Index 700-120 Enhanced Highway Signing Assemblies

COMMENTS AND RESPONSES

WRONG WAY HIGHLIGHTED SIGN ASSEMBLY

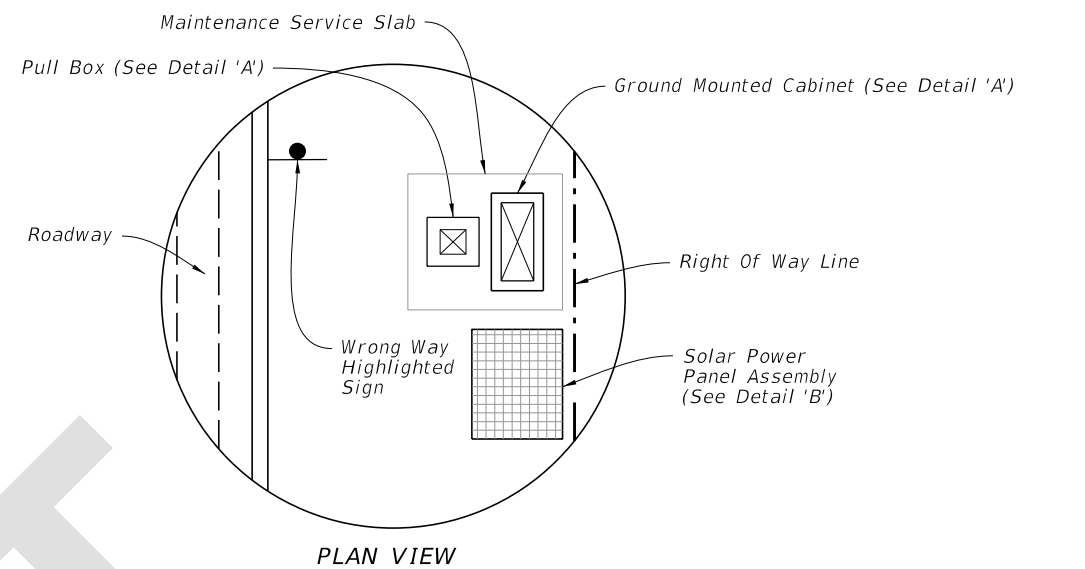
2. Newer version of WWD includes 2 sets of thermal detectors on top of the cameras. Recommend including all features to avoid extra details in the plans. The latest detection systems does not match with standard drawing.

2. Newer version of WWD includes 2 sets of thermal detectors on top of the cameras. Recommend including all features to avoid extra details in the plans. The latest detection systems does not match with standard drawing.

RESPONSE: The detector/camera types and specific placement of devices on the pole can vary by manufacturer. The standard plan is schematic in nature. Note 2 is intended to cover variability regarding exact type and placement of WWVDS components.

RESPONSE: The detector/camera types and specific placement of devices on the pole can vary by manufacturer. The standard plan is schematic in nature. Note 2 is intended to cover variability regarding exact type and placement of WWVDS components.

PLAN VIEW

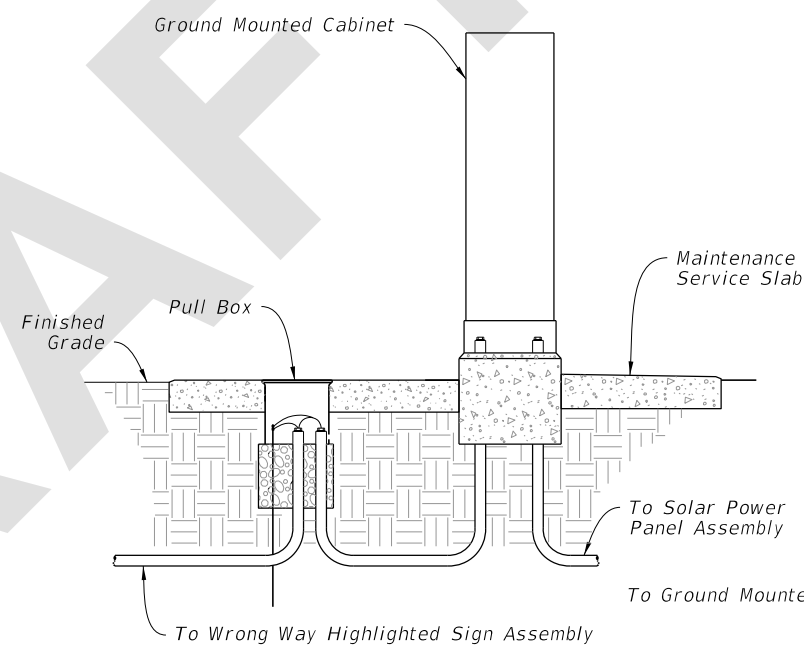
3. Maintenance person working in the cabinet will not be able to see the highlighted sign performance with the configuration shown on page 9.

RESPONSE: Agreed. Will update to place the cabinet and panels in a position slightly in front of the sign (so that the face is visible by technician at cabinet).

CHANGE MADE TO INDEX: Shifted cabinet and panels in plan view to be visible by technician.

DETAIL 'B'

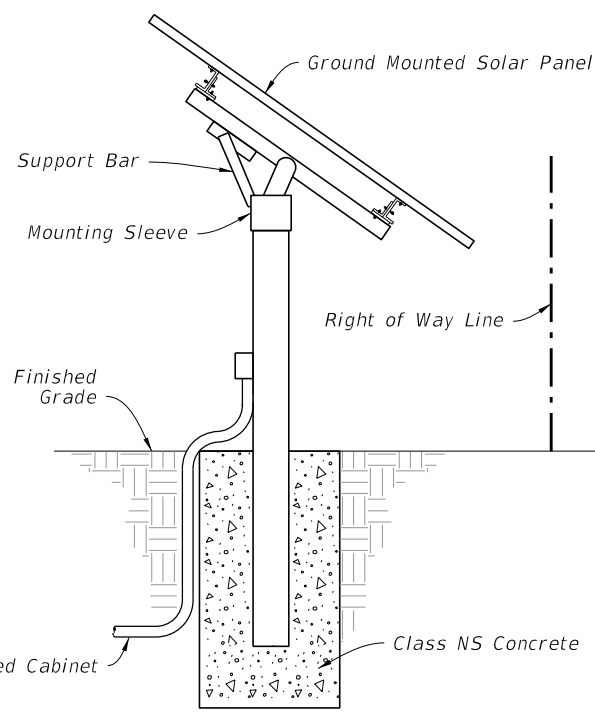
1. Detail B shows a solar panel on a pole:
 - a. What is the max height of the panel?
 - b. What is the max size of the panel?
 - c. How many panels can be attached to the pole?
 - d. What size/material is the pole?
 - e. *Note that the recently updated Tapco APL shows two sets of solar panels. The top panel is approx. 18ft above ground.

3. Detail B shows a solar panel on a pole: A transformer / breakaway base is not shown for the solar panel pole. Is it required?

4. Detail B shows a solar panel on a pole: Is the foundation diameter/depth/reinforcing for the solar panel pole shaft the same as for the other poles in this Index? If so, how is this information conveyed?

5. Detail B shows a solar panel on a pole: If a breakaway base is not used, what is the required embedment of the pole into the shaft?

RESPONSE: The drawing depicts a generic assembly that can vary based on site conditions, manufacturer, and power requirements. We will consider making a revision to the detail/notes to make it clearer that this detail is meant to be generic and that manufacturer recommendations must be met.

RESPONSE: Bases are allowed but are not required if outside clear zone. Placing them close to ROW is intended to keep them outside clear zone.

RESPONSE: The drawing depicts a generic assembly. Final foundation/depth/reinforcing for solar panel supports can vary by site conditions.

RESPONSE: The drawing depicts a generic assembly. Final foundation/depth/reinforcing for solar panel supports can vary by site conditions.
